ADDENDUM-1

ESP Sinter Dust Conveying System for SAIL Bokaro Steel Plant

Tender Ref: 77/24/6094/BPA

PRE BID CLARIFICATIONS
ESP Sinter Dust Conveying System for SAIL Bokaro Steel Plant -BHEL ISG
Tender ref. No. 77/24/6094/BPA

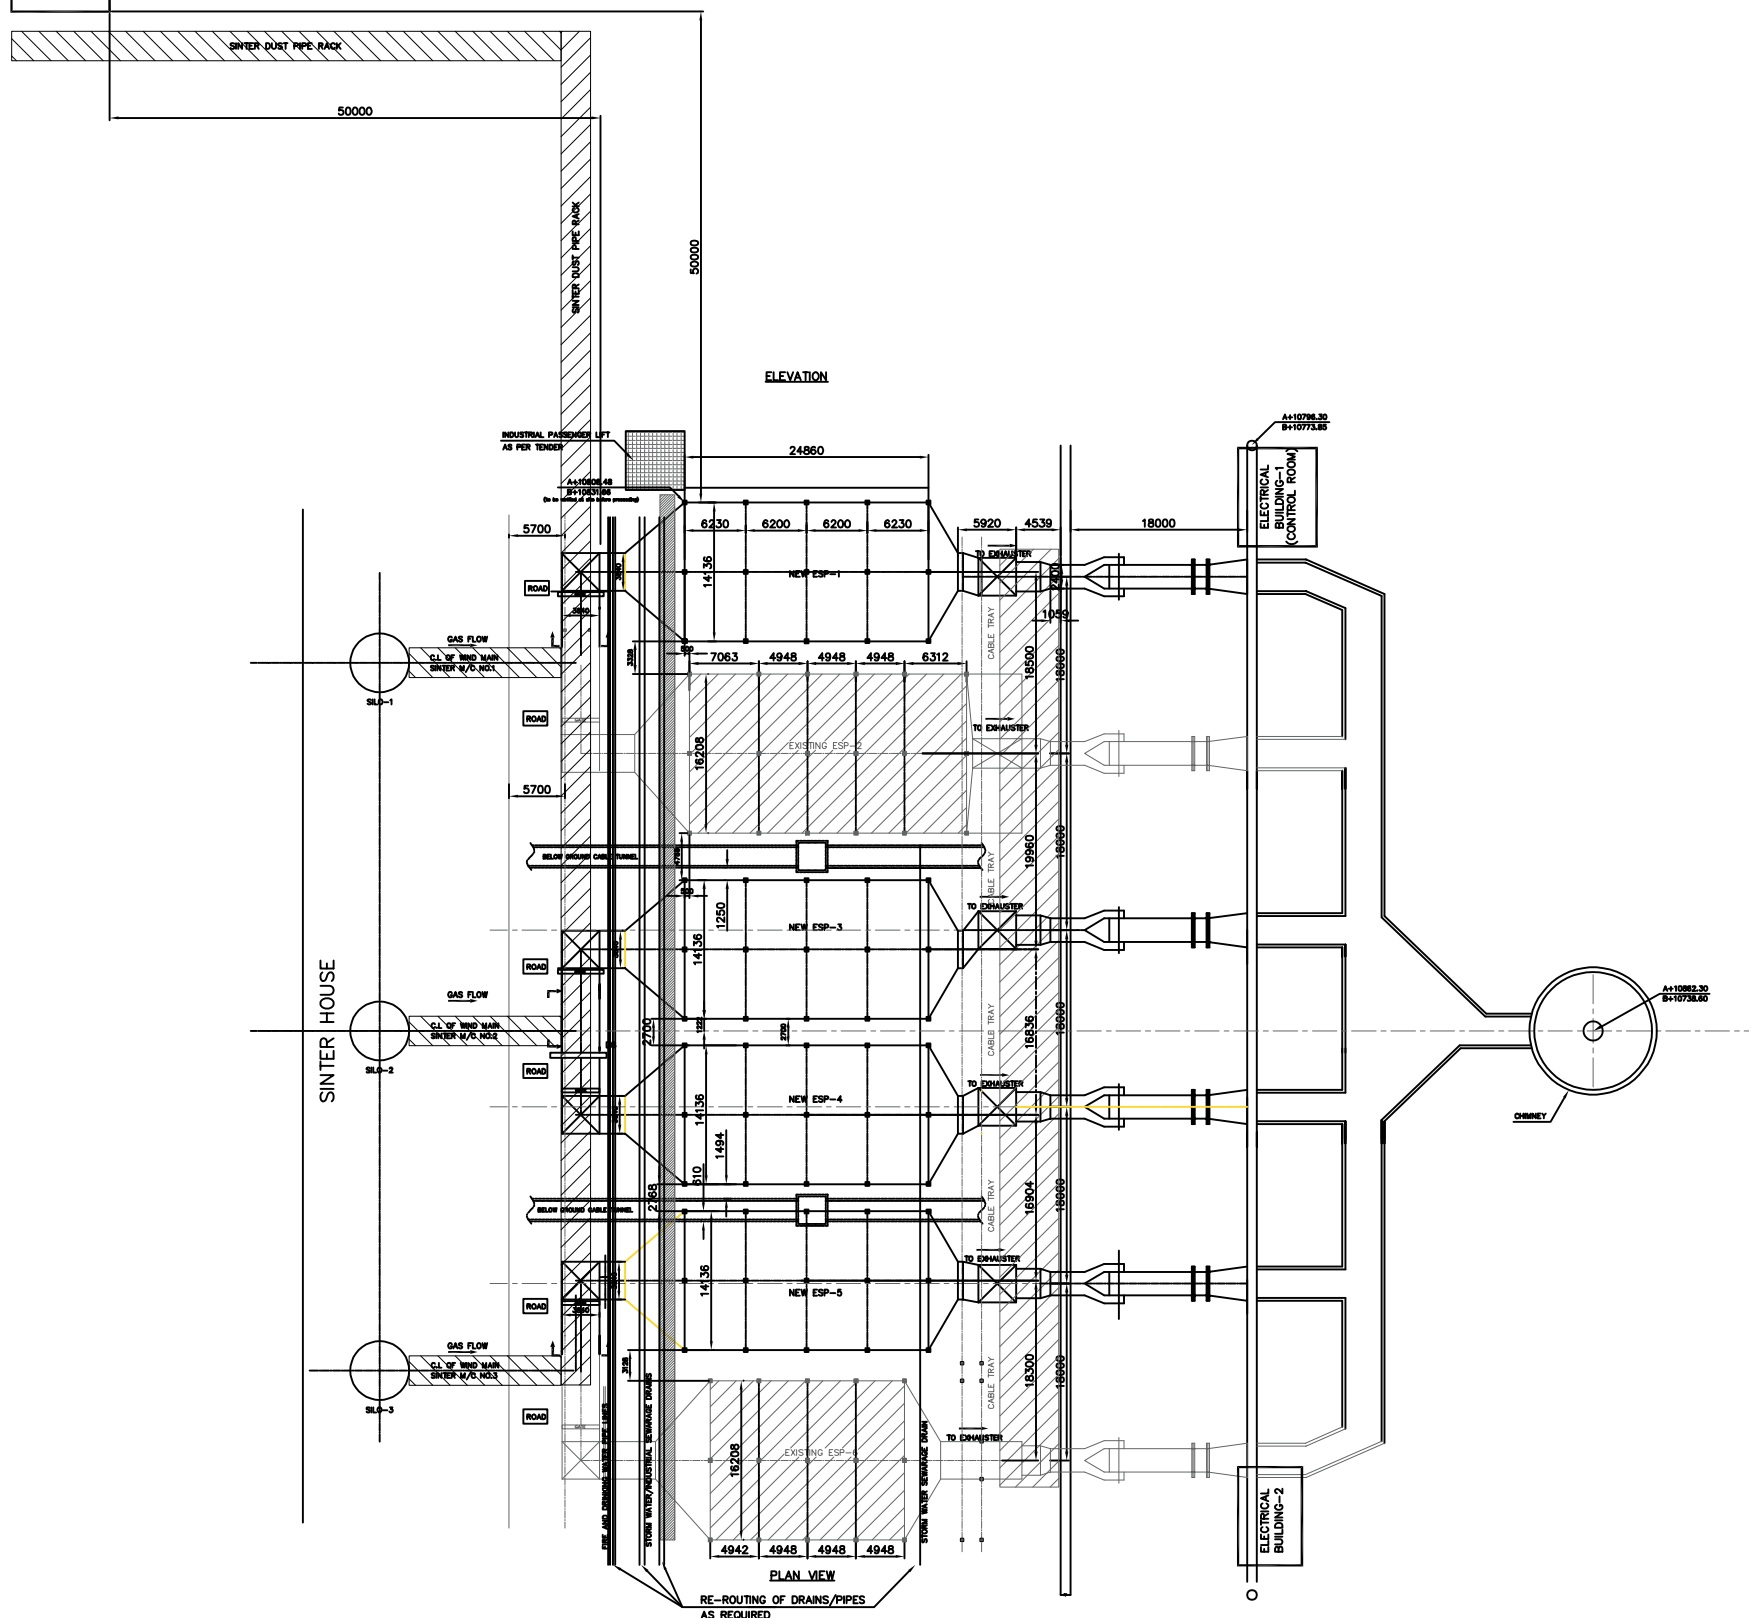
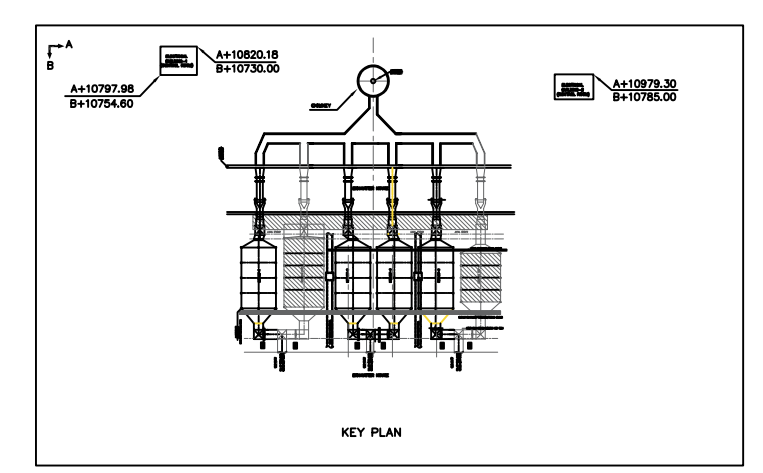
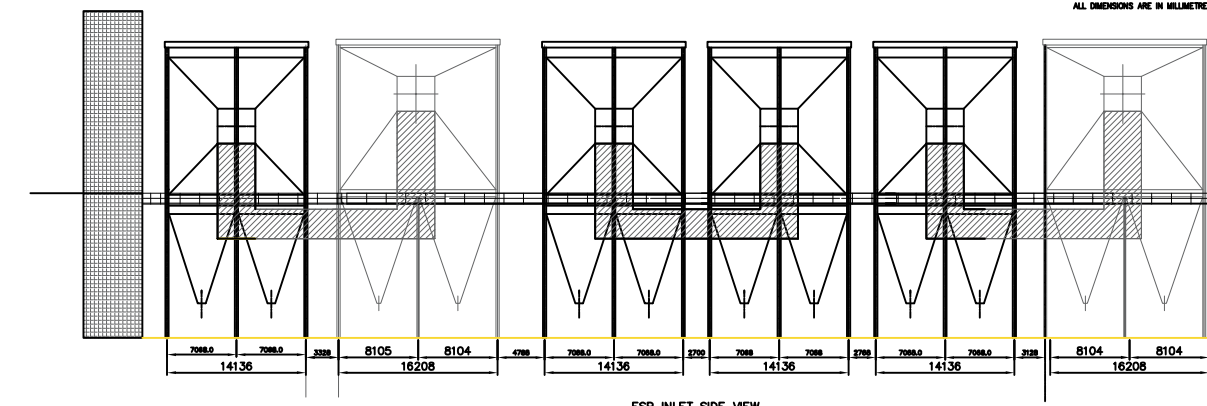
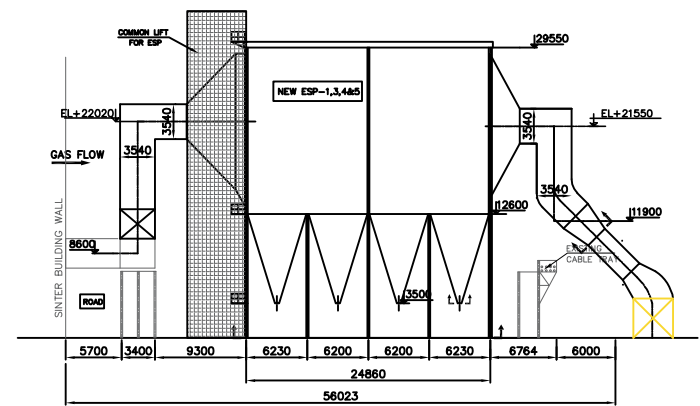
28				General		Attached Annexure-E6 - Below Ground Earth Grid for better clarity.
29	Annexure-3; GENERAL SCOPE MATRIX FOR ESP SINTER DUST PNEUMATIC CONVEYING SYSTEM (PCS) OF SAIL BOKARO-SP-1 (MECHANICAL and CIVIL)	A.1		Structural steel works for supporting of AHP equipment below hoppers, pipes, insert plates, grating, handrails, Chequered plates, local control panel, junction boxes in ESP area	Noted for the scope mentioned . Furthermore, Kindly note that we will not be submitting any STAAD files, structural designs, St GA or fab drg for the support of the area mentioned for approval. We will provide and install the supports on site in accordance with our internal design.	To be decided DDE.
30	Annexure-3; GENERAL SCOPE MATRIX FOR ESP SINTER DUST PNEUMATIC CONVEYING SYSTEM (PCS) OF SAIL BOKARO-SP-1 (MECHANICAL and CIVIL)	A.2		Structural silo 5m3, 8m3 with supporting structures including Bag Filter, Staircase for silo, gratings, Chequered plates, handrails, grouting works etc.	The scope of work for civil execution indicated in column (7) is not included in the M/s Schenck scope of work and is not taken into account by us. BHEL to take care the same .	Supply of foundation bolts as per structural design is in Mechanical bidder's scope. Civil foundation along with foundation bolt fixing is in BHEL's scope
